Benton County Solid Waste Process Workgroup

Subcommittee A.1 Landfill Size/Capacity/Longevity

Subcommittee Report to Workgroup

Revision 1-a crg – DRAFT crg 12-6-2022

Figure 1

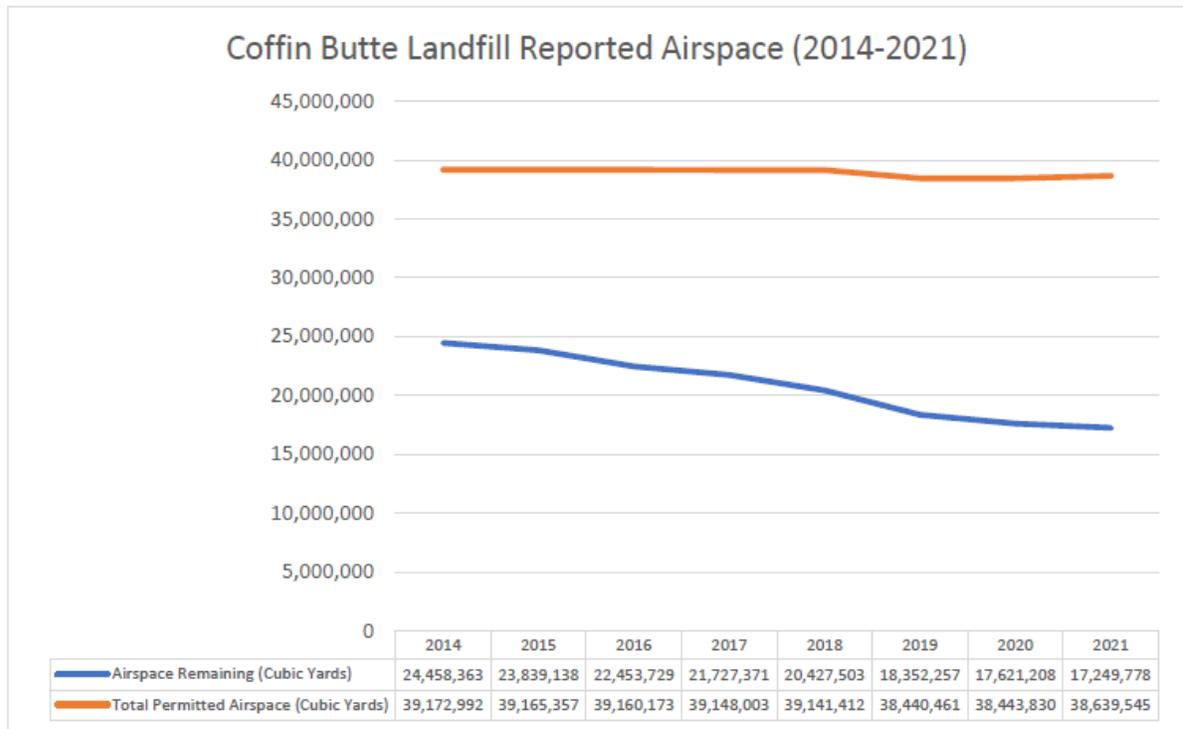
A plot of available/used capacity over time may be a useful reference. See Daniel's Reported Airspace (2014-2021) plot as an example:

Note that as of end 2021 approximately 44% of permitted capacity remained unused.

Figure 2

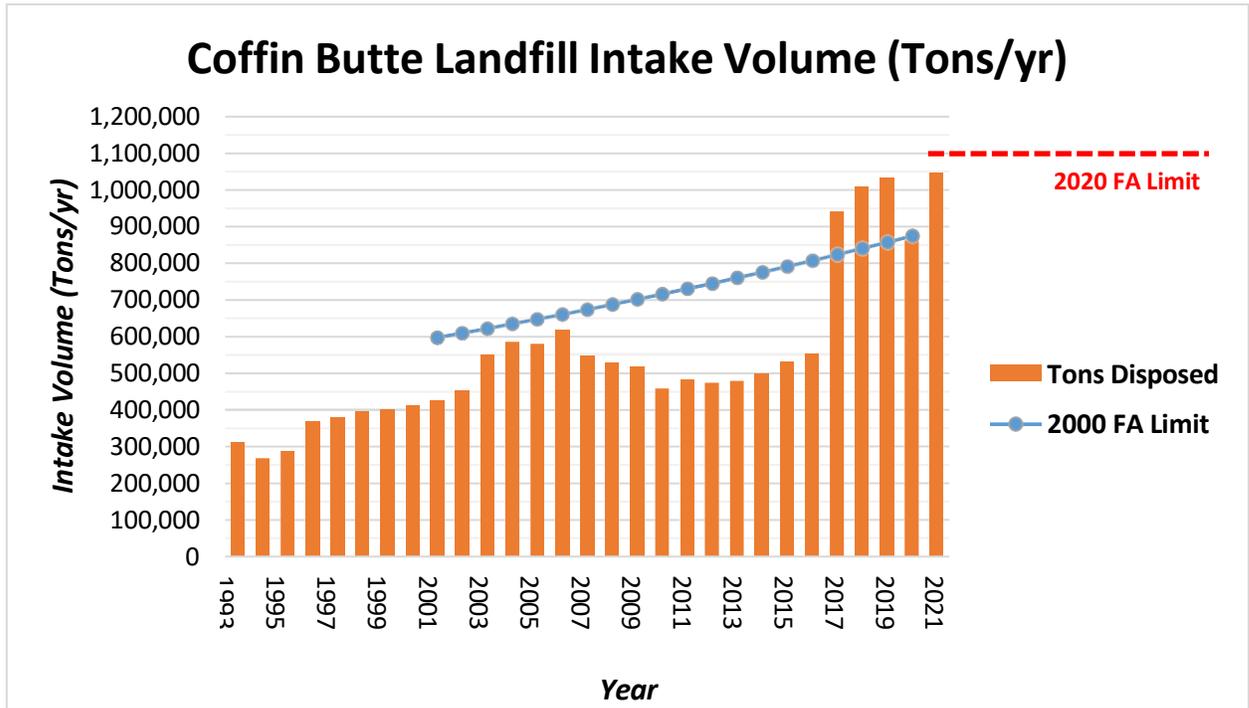
1. The 2000 Landfill Franchise Agreement imposed a ramping intake limit (cap) to be applied during the term of the agreement (CY2001-2019), denoted in the chart by the blue line ("2000 FA Limit").

2. Due to an expected additional influx of volume in 2017 resulting from the waste flow disruption into Riverbend landfill in Yamhill County, in December 2016 the franchisee and Benton County executed a MOU agreeing to an expected increase in Coffin Butte intake volume "for a term of 1-2 years."

3. In documents provided to the A.1 Subcommittee, representatives of the franchisee have indicated that the approximately 70% year-over-year increase in CY2016-2017 was due to redirected flow from Riverbend to Coffin Butte.

4. The 2020 Landfill Franchise Agreement defined a flat intake limit (cap) of 1.1M Tons/yr. unless expansion was fully permitted onto the "expansion parcel" (i.e. the lot south of Coffin Butte Road zoned LS in 1983 but at that time restricted to non-disposal activities); upon this expansion approval the intake limit would be eliminated. The 2020 intake limit is denoted in the chart by the dashed red line ("2020 FA Limit").

5. The slow downward trend in intake volume in the 2017-2012 period is explained by the franchisee as resulting from the economic downturn of 2008.
6. The decreased intake volume in 2020 is attributed to the Covid-19 outbreak.

Figure 3

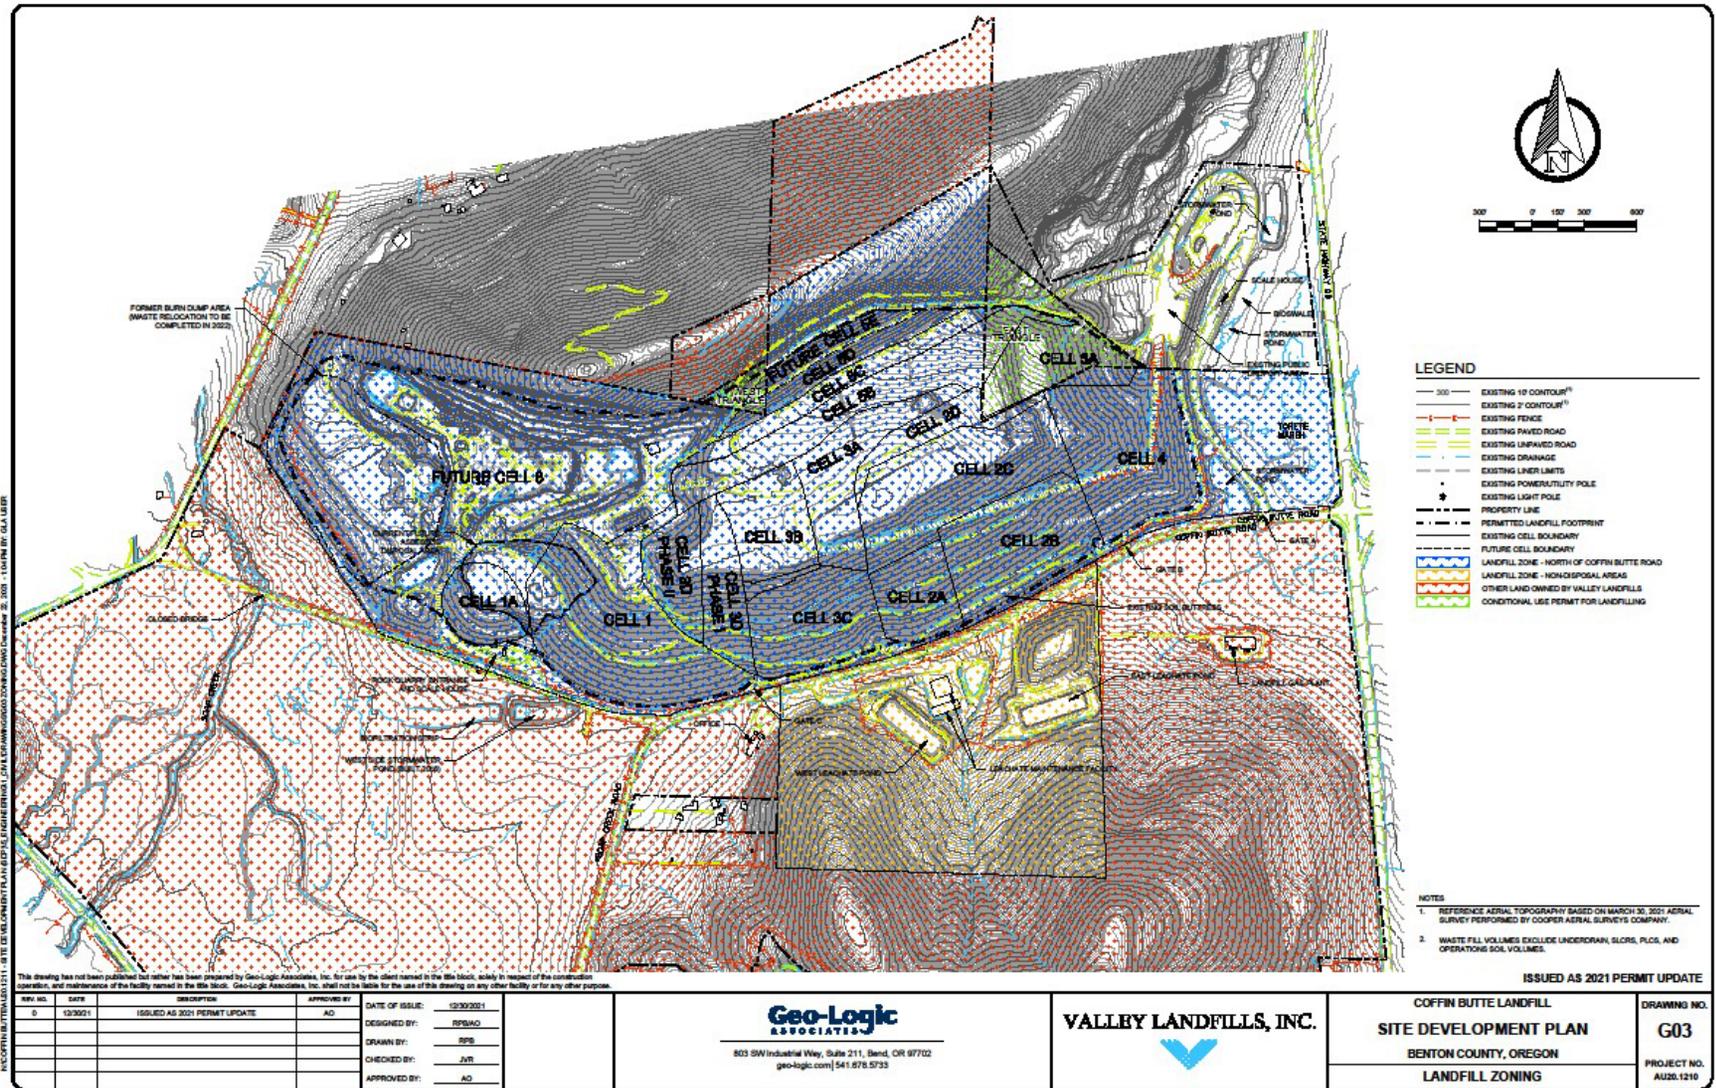
The disposal area and surrounding lots are shown in Figure 3 below. This drawing is reproduced from the 2021 Site Development Plan, Appendix A, Drawing No. G03, and is reproduced here for convenience.

Drawing below imported from pdf; quality degraded. Better means of importing into Word?
